# Access Compliance Report

## Public Rights-of-Way

Intersection ID: 27404	Main Street: BALLANTYNE_COMMONS_PY	Cross Street: MEADOW_RUN_LN	Location: NE
ADA ID: E57D5469C51A	Ramp Type: Perp	Initial Pass/Fail: Fail	Overall Compliance: No
Severity Score: 22.5			
Codes/Mitigation Info/Possible Solution		Field Measurements/Component Compliance

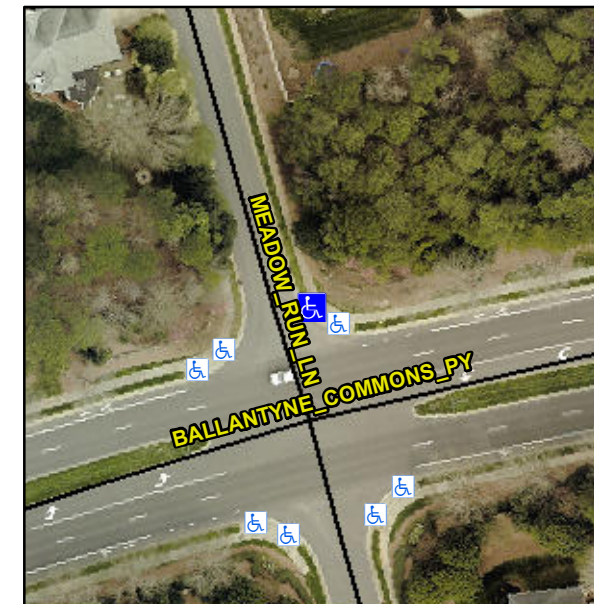
**Not Found, R304.5.1, R304.2.2, R304.5.3**

Compliance	Description	Data	Compliance	Description	Data
N/A	Ramp Length (in)	47.0	No	Ramp Slope (%)	10.4
No	Ramp Width (in)	44.5	No	Ramp XSlope (%)	4.5
N/A	Flare Type LT	N/A	N/A	Flare Type RT	N/A
N/A	Flare Slope LT (%)	N/A	N/A	Flare Slope RT (%)	N/A
N/A	Flare Traversable LT?	N/A	N/A	Flare Traversable RT?	N/A
N/A	Landing Length (in)	N/A	N/A	DWS Provided?	N/A
N/A	Landing Width (in)	N/A	N/A	DWS Contrast?	N/A
N/A	Landing Slope (%)	N/A	N/A	DWS Length (in)	N/A
N/A	Landing X Slope (%)	N/A	N/A	DWS Full Width?	N/A
N/A	Landing Curb? (Y/N)	N/A	N/A	DWS Offset (in)	N/A
N/A	Shared Landing?	N/A			
N/A	Gutter Ponding?	N/A	N/A	Gutter Slope (%)	N/A
N/A	Gutter Lip Ht (in)	N/A	N/A	Gutter X Slope (%)	N/A
N/A	Painted X Walk1?	No	N/A	Painted X Walk2?	N/A
	X Walk 1 Direction	To SW		X Walk 2 Direction	N/A
N/A	X Walk 1 Width (in)	N/A	N/A	X Walk 2 Width (in)	N/A
	X Walk 1 Slope (%)	2.3		X Walk 2 Slope (%)	N/A
	X Walk 1 X Slope (%)	3.2		X Walk 2 X Slope (%)	N/A

**Remove & Replace Entire Ramp.**
